PARTS & SERVICE NEWS

REF NO.	AA00091
DATE	09, June 2000

SUBJECT: Door Window Assemblies

PURPOSE: Replacement of discontinued window glass assembly

Figure 1. Door Panel Structure

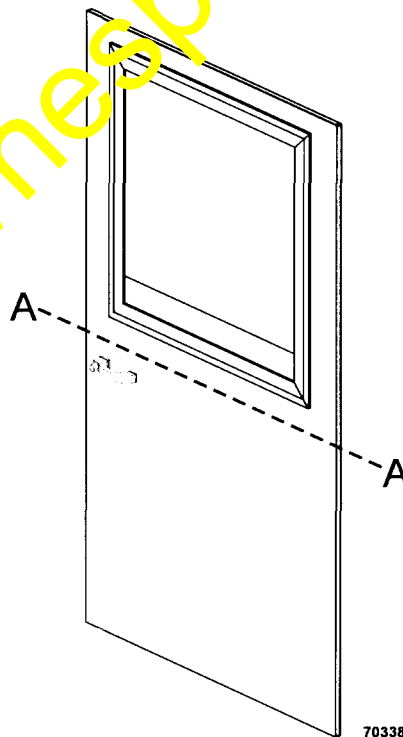
When manufactured, the heat from the welding of the stiffeners may cause the door to bow and push outward. The bowing of the door causes the window channels to turn inward putting pressure on the glass by pushing it against the inside window seal hard enough that the window will not operate.

1. Assure that the door structure is relatively flat as shown (Line A-A, Figure 1). To remove the bow from the door, lower the window and apply a smooth, even pulling force from inside the cab until door structure is flat..
2. Remove the inside seal (2, Figure 2) from the armrest portion of the door structure to allow enough clearance between the door glass (1, Figure 2) and the armrest (3, Figure 2). **NOTE: REMOVING THE INSIDE SEAL MAY ALLOW DIRT AND MOISTURE TO ENTER THE CAB DURING OPERATION BUT ONLY FROM INSIDE THE CAB UNLESS THE WINDOW IS DOWN.**

Figure 2. End View Of Door Panel

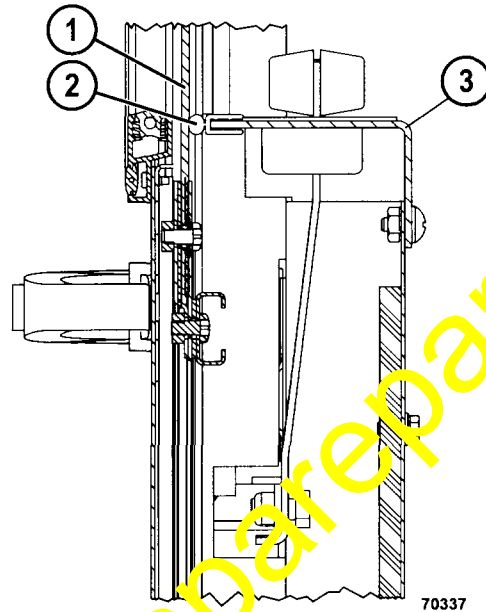
When the new door window assembly is installed, the seal asserts more pressure on the outside of the glass. This causes the window to be pressed against the inside seal hard enough that some windows may not be able to go up or down under motor power properly.
